# **Transitional Programme - Newtown to city accessibility audit**

Final

**Prepared for:** Wellington City Council

**Prepared by:** MRCagney (NZ) Ltd, Auckland, New Zealand

**Figure 2 Excerpt from plan - Riddiford Street / Mein Street / Hall Street intersection (C101A)**

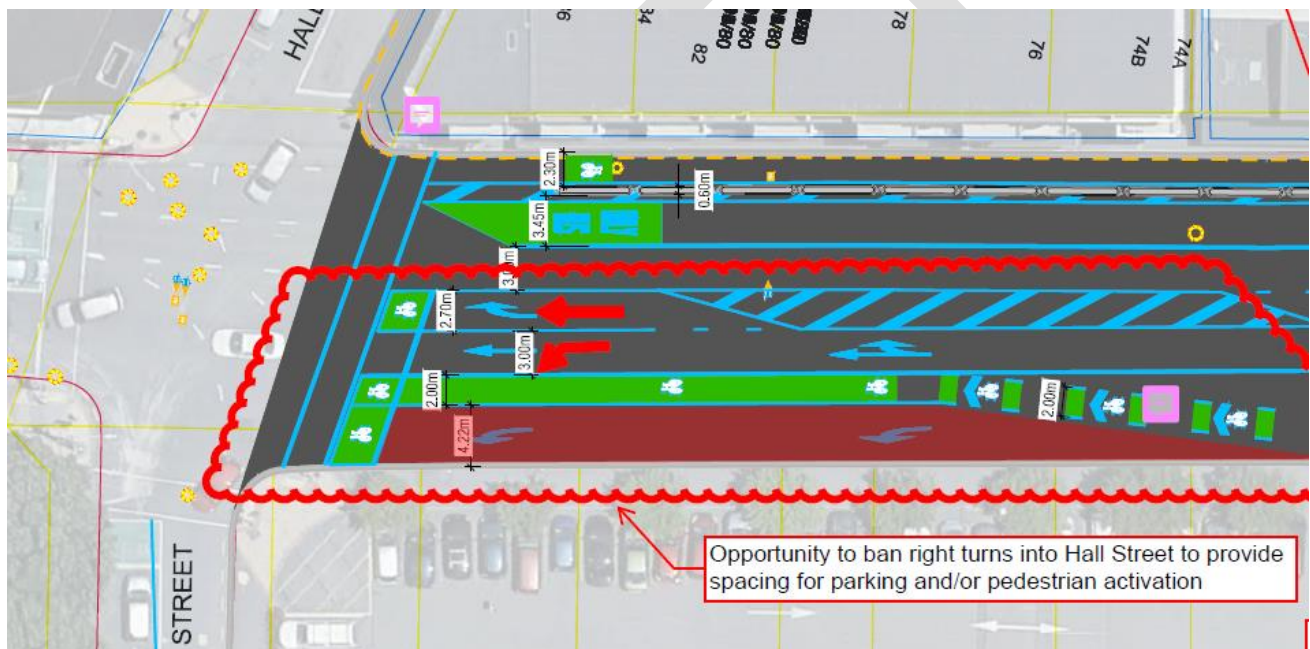
Figure 2 shows the cycle lane crossing over into the middle of the traffic lanes allowing a left turn vehicle lane servicing Mein Street. Consideration should be given regarding the potential conflict between cyclists and vehicles crossing paths because this design may render the route inaccessible to less confident cyclists.

Figure 2 shows the crossing width of Riddiford Street at Hall and Mein Street intersection which requires pedestrians to cross seven lanes of traffic (including cycle lanes). The crossing time and width may be intimidating to people who walk slower than an average pace. Consideration should be given to pedestrian timing phases at signalised intersections.

Cycle lane / Left turn lane conflict	
Access principle(s):	Safe
Overall Rating	Major
Designer response	Board decision was to keep the Riddiford St/ Mein St intersection in its current layout and to not ban the right turn into Mein St
Safety Engineer response	Agree with the Designer. The reference being not to ban the left turn into Mein Street.

Cycle lane / Left turn lane conflict	
<b>Client decision</b>	We have amended the designs to continue the separated cycle facility all the way to the intersection with dedicated cycle phasing to remove any cycle vehicle conflict
<b>Action taken</b>	Amended proposed designs

Pedestrian phase crossing width and time	
<b>Access principle(s):</b>	<b>Safe</b>
<b>Overall Rating</b>	<b>Minor</b>
<b>Designer response</b>	Board decision was to keep the Riddiford St/ Mein St intersection in its current layout and to not ban the right turn into Mein St
<b>Safety Engineer response</b>	Agree with Designer.
<b>Client decision</b>	Agree with above, no action required but monitor the pedestrian phase and give additional time if required
<b>Action taken</b>	Monitor pedestrian phase

**Figure 3 Riddiford Street - shared path cycle lane (C101A)**

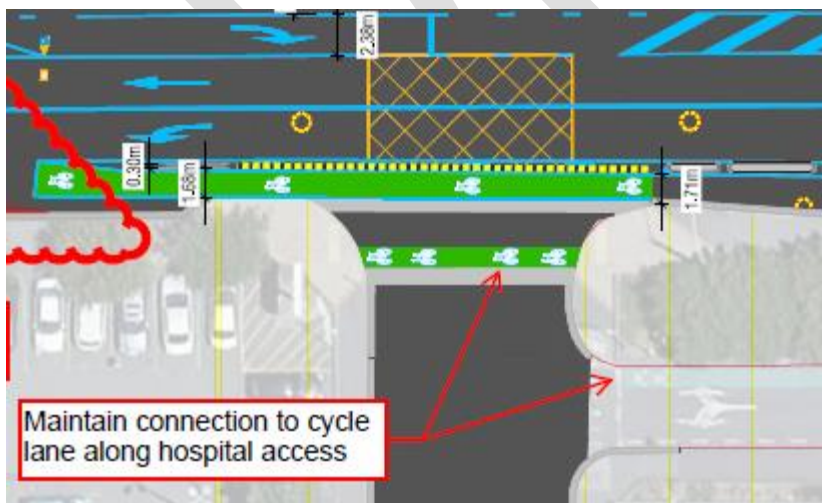
Figure 3 shows plans to retain an existing shared cycle path across an accessway to Wellington Hospital which runs parallel to the proposed new cycle lane. Consideration should be given as to whether this cycle lane is necessary and what its purpose is, as this may confuse pedestrians and cyclists alike. It is recommended to link existing on-site cycle infrastructure to the proposed new cycle lane to reduce confusion.

<b>Bus bypass stops</b>	
<b>Access principle(s):</b>	<b>Safe / Obvious</b>
<b>Overall Rating</b>	<b>Minor</b>
<b>Designer response</b>	To be removed in 60% designs
<b>Safety Engineer response</b>	Agree with Auditors and Designer.
<b>Action taken</b>	Removed in 60% designs

Figure 4 Excerpt from plan - Riddiford Street - bus bypass stops (C101A)

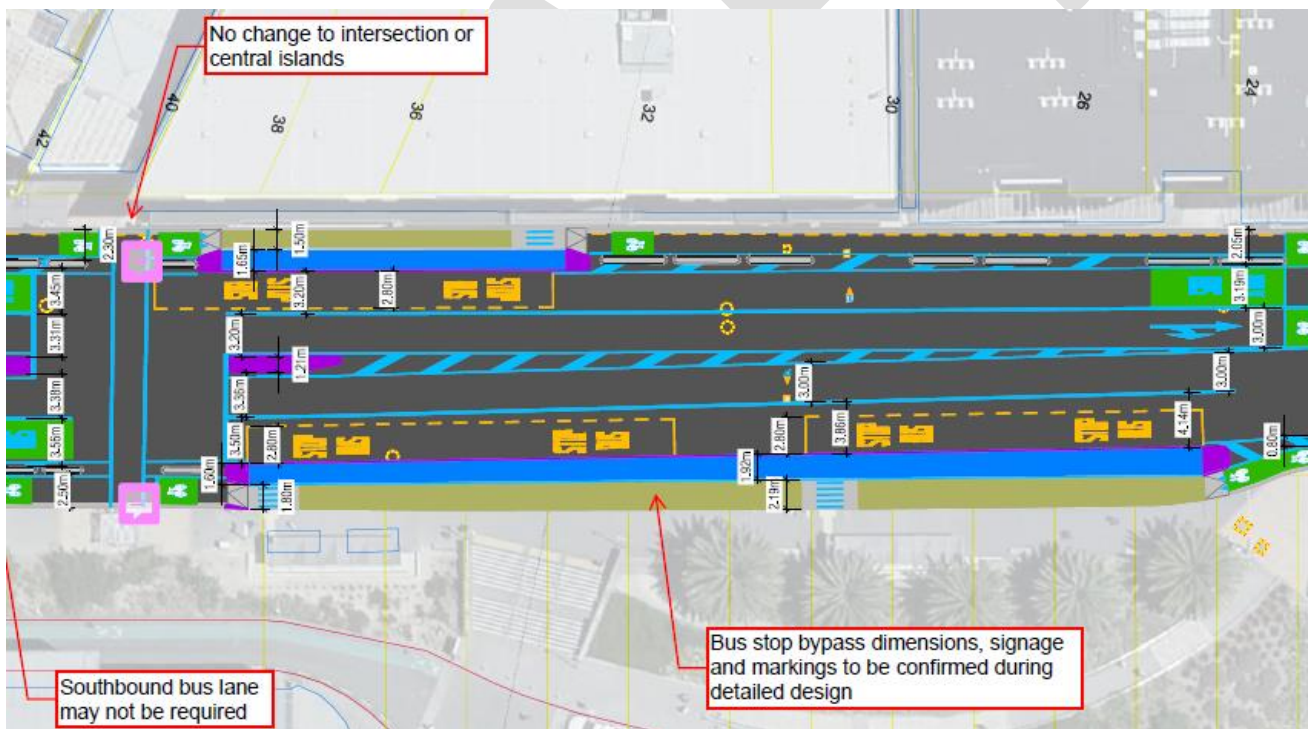
The proposed bus bypass layout proposed outside Wellington Hospital should be considered carefully as to whether the layout is safe and obvious for everyone using it. A separate audit of bus stop designs on the cycleway and further consultation with the disability sector is recommended prior to the design being finalised.

<b>Bus bypass stops</b>	
<b>Access principle(s):</b>	<b>Safe / Obvious</b>
<b>Overall Rating</b>	<b>Major</b>

<b>Bus bypass stops</b>	
<b>Designer response</b>	Unclear what the recommendation is. Bus stop bypasses are a transport industry recognised design solution to the conflict between stationary bus and cyclist
<b>Safety Engineer response</b>	Agree with Designer. However, given that the use of bus bypasses is relatively novel in Wellington and that this is a transitional cycleway, behaviour should be monitored, with any issues being resolved in further design and use.
<b>Action taken</b>	Independent accessibility audit on the bus platform undertaken.  Education and behaviour change campaign developed to complement installation of new platforms

**Figure 5 Excerpt from plan - Riddiford Street - hospital access intersection (C101A)**

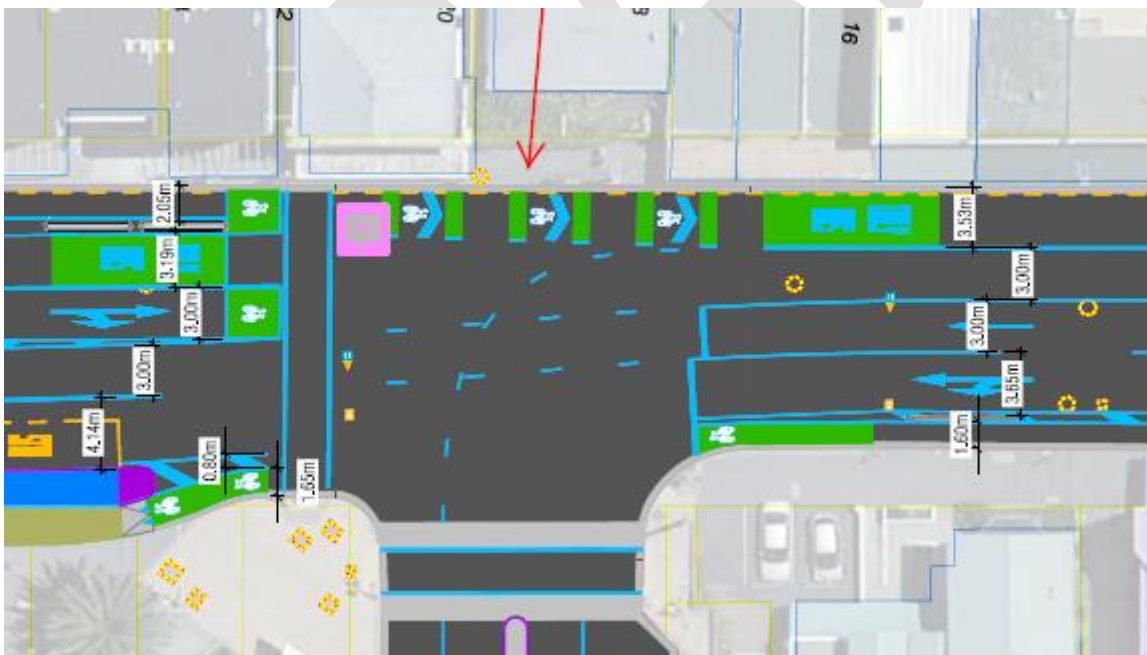
Figure 5 shows plans to merge cyclists with buses where Riddiford Street intersects with the main entrance to Wellington Hospital. Cyclists may perceive this proposed direction as unsafe, which may influence their decision to use the cycle lane altogether. The design plans specify the intention to provide an advance green signal for cyclists to allow them to move out through the intersection in front of waiting buses. This proposal does not account for cyclists who are travelling up to the intersection and miss the advance signal resulting in them merging in between buses. Consideration should be given to the design and layout of the cycling infrastructure through this intersection.

<b>Cycle lane / Bus lane merge</b>	
<b>Access principle(s):</b>	<b>Safe</b>

Cycle lane / Bus lane merge	
<b>Overall Rating</b>	<b>Major</b>
<b>Designer response</b>	Decision from intersection modelling results workshop was a shared bus/cycle lane in the northbound direction due to a lack of space at the John St intersection.
<b>Safety Engineer response</b>	Agree with Designer. Monitor cyclist behaviour and revisit if there is a safety problem
<b>Action taken</b>	Additional signage and road markings with buffer included to ensure safer merge area of cyclists and buses.

**Figure 6 Excerpt from plan - Riddiford Street / Adelaide Road / John Street intersection (C102A)**

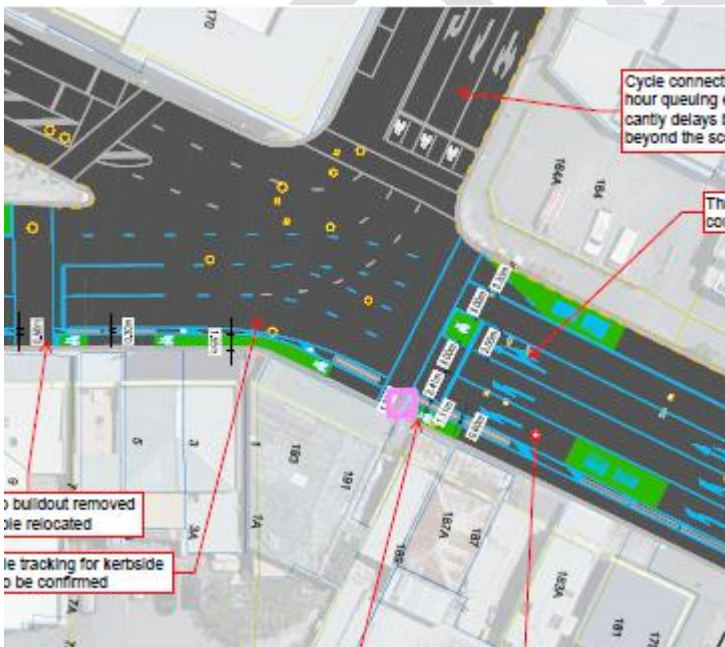
Figure 6 shows a southbound separated cycleway on Adelaide Road. The cycle lane continues through the signalised intersection and down Riddiford Street. Design consideration should be given to ensure cyclists are aware they are still under signal control on approach to the intersection to prevent conflict between cyclists and pedestrians when crossing under signal.

Access to the Adelaide Road southbound right-turn advanced cycle box should be considered, for example with markings so that everyone using the street is aware that cyclists may cross traffic lanes to turn right at this intersection.

<b>Separated cycle lane under signal</b>	
<b>Access principle(s):</b>	<b>Safe / Obvious</b>
<b>Overall Rating</b>	<b>Major</b>
<b>Designer response</b>	Traffic signals apply to cyclists as per the road code. The pedestrian crossing lines will take priority over cycleway markings at crossing points
<b>Safety Engineer response</b>	Agree with Designer.
<b>Action taken</b>	No action required.

<b>Access to advanced cycle box</b>	
<b>Access principle(s):</b>	<b>Safe / Obvious</b>
<b>Overall Rating</b>	<b>Minor</b>
<b>Designer response</b>	Will extend the bus box in the northbound direction to 6m. Is no available space to widen the shared bus/cycle lane any further
<b>Safety Engineer response</b>	I don't think the Designer's response addresses the issue for access to the SB ASB. It may be that additional pavement markings are necessary.
<b>Action taken</b>	Monitor the situation add additional road markings if required.

Figure 7 Excerpt from plan – proposed shared path on Adelaide Road (C201A)

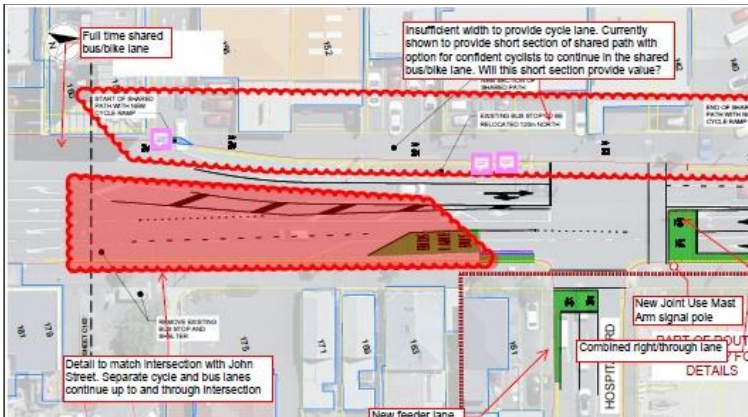
Figure 7 shows the proposed shared path between 138 and 160 Adelaide Road. Shared paths are neither safe nor obvious for pedestrians, particularly on busy streets where an increase in cycling is expected. It is recommended that the allocation of space on the street is reconsidered to provide separate facilities. In the shared path context:

- The northbound cycle lane entry onto the shared path appears to create a pinch point between pedestrians and cyclists. A minimum footpath width of 2.0 metres and cycle lane width of 1.6 metres are recommended. Consideration should be given to the design and location of the cycle lane entry point to confirm sufficient width is provided for everyone.

- The adjoining businesses along this section of the shared path have off-street parking with several that can only reverse out of parking spaces. This creates an additional risk to both pedestrians and cyclists. Consideration should be given as to how this risk of conflict will be mitigated, for example through removal of reverse-only off-street parking spaces.

- Consideration of installing tactile guidance surface indicators (TGSi) on cycle lane entry and exit to shared path will provide guidance to blind people and those with vision impairment that they are entering a different environment from an exclusive footpath.

- The shared path should be clear of obstructions including power / lighting poles, utility boxes and street furniture.

Figure 7 shows the side road between 175 and 179 Adelaide Road closed off with a short pedestrianised area. It is recommended that wayfinding signage is installed.

<b>Shared path</b>	
<b>Access principle(s):</b>	<b>Safe / Obvious / Step Free</b>
<b>Overall Rating</b>	<b>Major</b>
<b>Designer response</b>	To remove shared path in 60% designs with cyclists to use shared bus/cycle lane
<b>Safety Engineer response</b>	Agree with Auditor’s and Designer.
<b>Action taken</b>	Removed shared path from plans.

<b>Wayfinding - Pedestrianised area</b>	
<b>Access principle(s):</b>	<b>Obvious</b>
<b>Overall Rating</b>	<b>Comment</b>
<b>Designer response</b>	Pedestrian wayfinding is outside of transitional cycleways scope because the wayfinding signage is intended for cyclists using the new cycleways. The closure of the side street is existing and will not change as part of transitional cycleways
<b>Safety Engineer response</b>	Comment to be noted and addressed outside of this project.
<b>Action taken</b>	Wayfinding out of scope. No action required.

**Figure 8 Drummond Street signalised pedestrian crossing (C201A)**

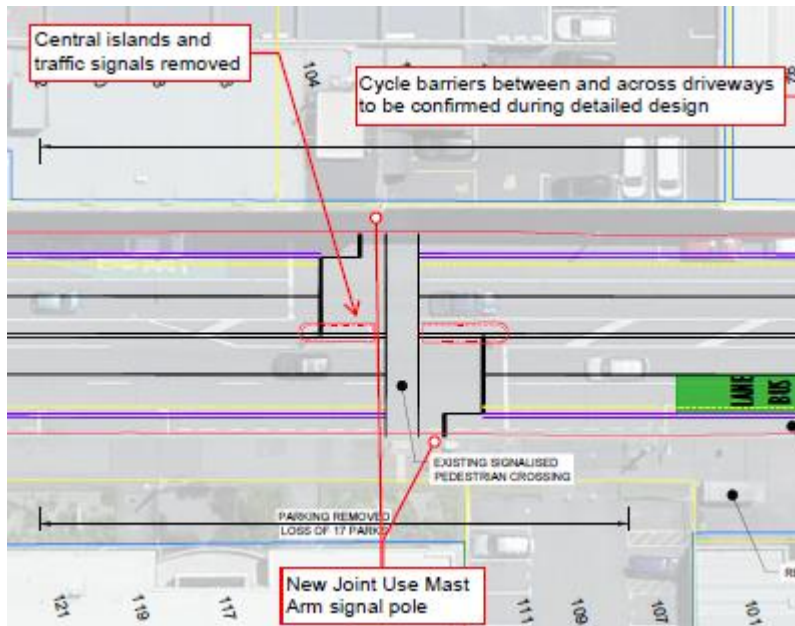
Figure 8 shows the existing Drummond Street signalised pedestrian crossing which provides detail that the central pedestrian refuge is to be removed. Consideration of retaining this refuge is recommended to improve pedestrians' confidence crossing a wide carriageway with six lanes (including cycle lanes) of relatively high-speed traffic.

Wayfinding - Pedestrianised area	
<b>Access principle(s):</b>	<b>Safe</b>
<b>Overall Rating</b>	<b>Minor</b>
<b>Designer response</b>	Space currently used for central island is required to fit cycleway within existing carriageway
<b>Client decision</b>	Agree with Designer. Crossing timings should be checked to ensure that slower pedestrians will not be caught short in their crossing.
<b>Action taken</b>	Agree with above, monitor signal phasing.

**Figure 9 Excerpt from plan - Adelaide Road (C201A)**

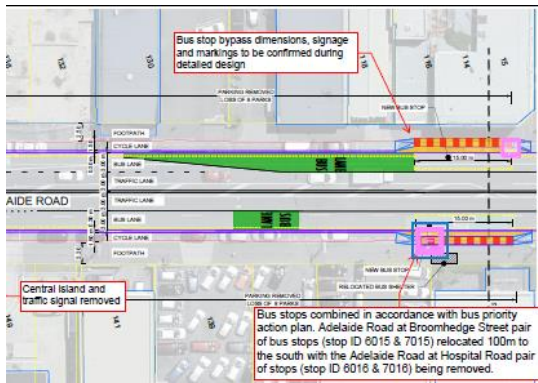
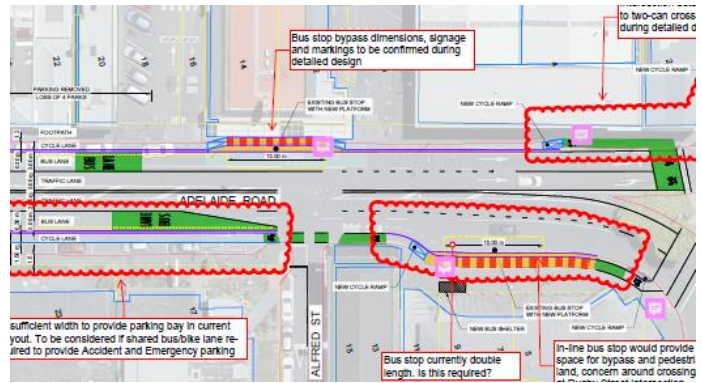
Figure 9 and Figure 10 show proposed bus stop bypasses with further detail to be included at detailed design phase. As discussed above, further consideration should be given to ensure these bus stops are safe, obvious and step free for everyone. A further accessibility audit and consultation with the disability sector is recommended.

Cycle lane - Bus stop bypasses	
Access principle(s):	Safe / Obvious
Overall Rating	Major
Designer response	Unsure what the recommendation is
Safety Engineer response	I think this is the same as 2.2.3. As with that, given that the use of bus bypasses is relatively novel in Wellington and that this is a transitional cycleway, behaviour should be monitored, with any issues being resolved in further design and use.
Action taken	Independent accessibility audit on the bus platform undertaken.

Figure 11 Excerpt from plan - Adelaide Road / Rugby Street intersection – shared path (C202A)

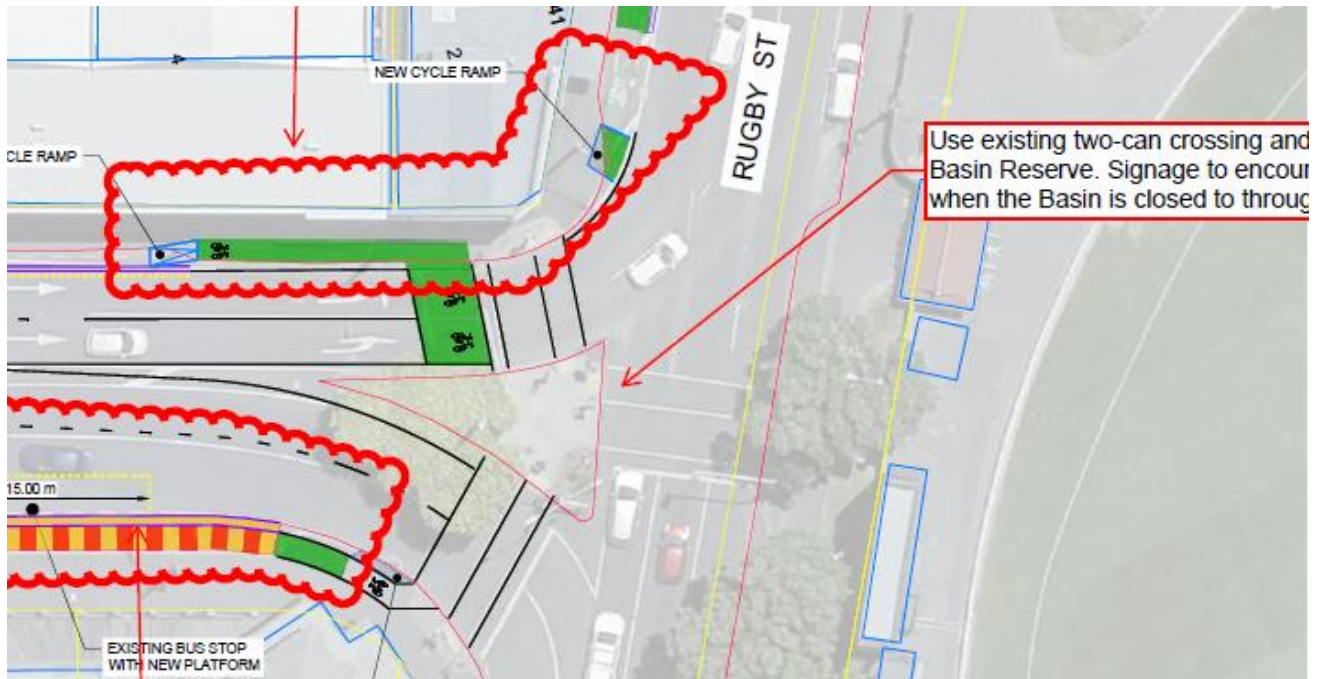
Figure 11 shows the proposed cycle lane merging with the footpath on both sides of Adelaide Road at Rugby Street intersection, creating short sections of shared path. Shared paths are neither safe nor obvious, particularly for the most vulnerable pedestrians in locations where the numbers of cyclists is expected to increase. Consideration should be given to retain a continuous 2-metre wide footpath for pedestrians and 1.6 metre wide cycle lane to avoid conflict between cyclists and pedestrians. Physical detectable separation of cyclists and pedestrians is recommended.

<b>Shared path merge</b>	
<b>Access principle(s):</b>	<b>Safe / Obvious</b>
<b>Overall Rating</b>	<b>Major</b>
<b>Designer response</b>	Is not enough space for a separate cycleway up to the limit line of the traffic signals because the traffic lanes are already at a minimum width of 3m and moving kerblines are out of scope. A cycle ramp, green paint and cycle symbol will make it clear to cyclists that the shared path is an option
<b>Safety Engineer response</b>	Agree with Designer. The detailed design shared path markings should be further reviewed to ensure that expected behaviour is clear to all users.
<b>Action taken</b>	LGWM to include this section in targeted improvement. Shared path signage and road markings clear.

Figure 12 Excerpt from plan - Cambridge Terrace / Kent Terrace signalised pedestrian crossing (C301A)

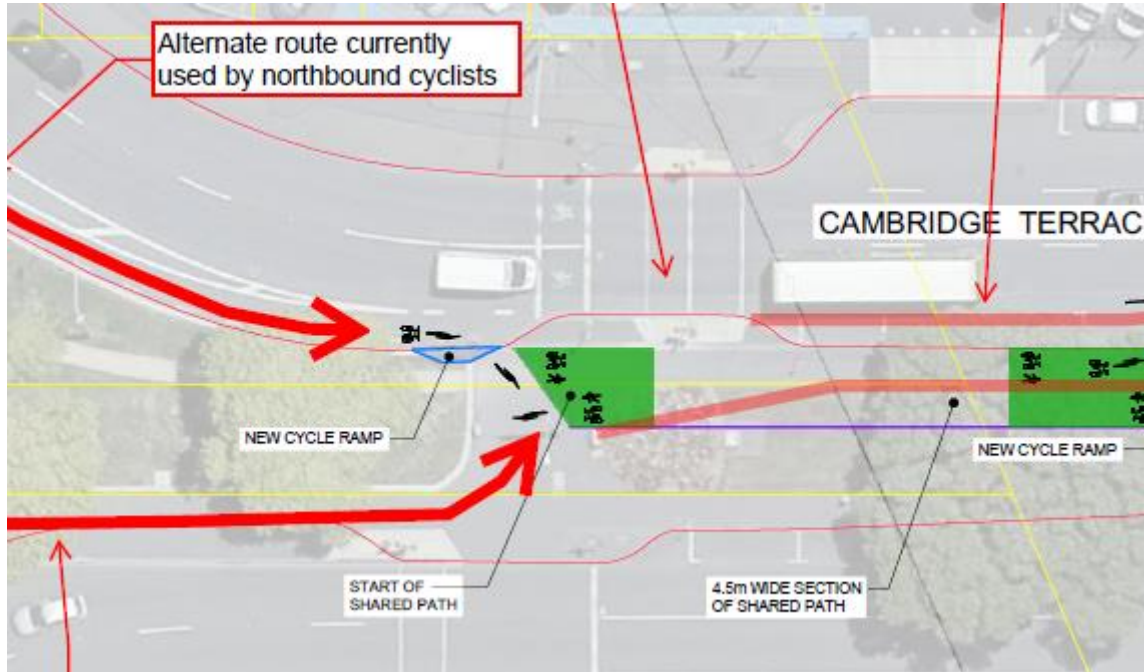
Figure 12 shows the existing signalised pedestrian crossing and proposed shared path in the central median. Shared paths are not safe or obvious for many pedestrians. Consideration should be given to separating cyclists and pedestrians at this location.

Signalised pedestrian crossing	
Access principle(s):	Safe / obvious
Overall Rating	Minor
Designer response	Is not enough space for separate cycleway and footpath. Furthermore cyclists and pedestrians will share space through the basin reserve so this section of shared path is in context
Safety Engineer response	Agree with Designer. Although the Auditor's earlier point 2.1.7 is noted as being part of this context. The wayfinding and signage through the Basin Reserve needs to be completed and reviewed in context with this.
Action taken	Wayfinding signage through Basin to be investigated.

**Table 2 Excerpt from plans - Cambridge Terrace / Kent Terrace – turning locations (C301A-C302A)**

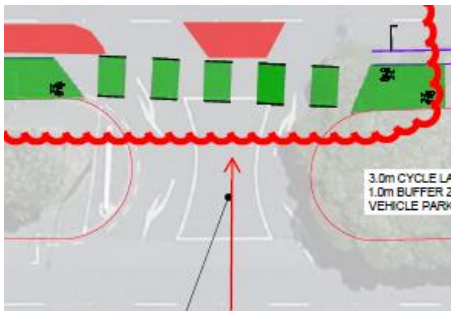
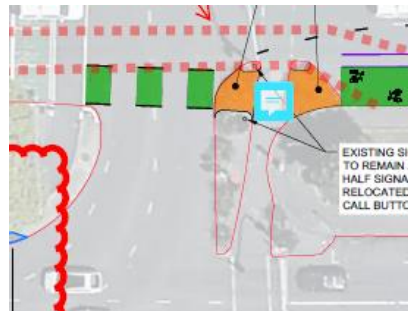
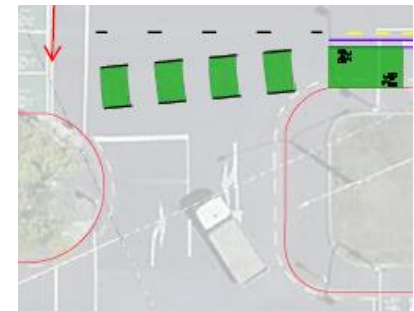
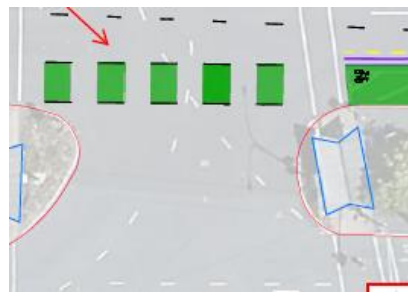
Figure 13 to Figure 17 show five turning locations along Cambridge Terrace and Kent Terrace that intersect the central median and the proposed shared path. Design consideration needs to be given as to how priority at signalised intersections will be managed for southbound cyclists travelling in a contraflow direction to northbound-facing signals. At non-signalised crossings, the design must be clear as to who has priority. This priority at intersections should be consistent throughout the route to avoid confusion.

Priority at turning locations	
Access principle(s):	Safe / Obvious
Overall Rating	Major
Designer response	Agree with accessibility audit, to investigate north facing cycle symbols as part of intersection details
Safety Engineer response	Agree with Auditors and Designer.
Action taken	Intersection safety in design workshops undertaken.
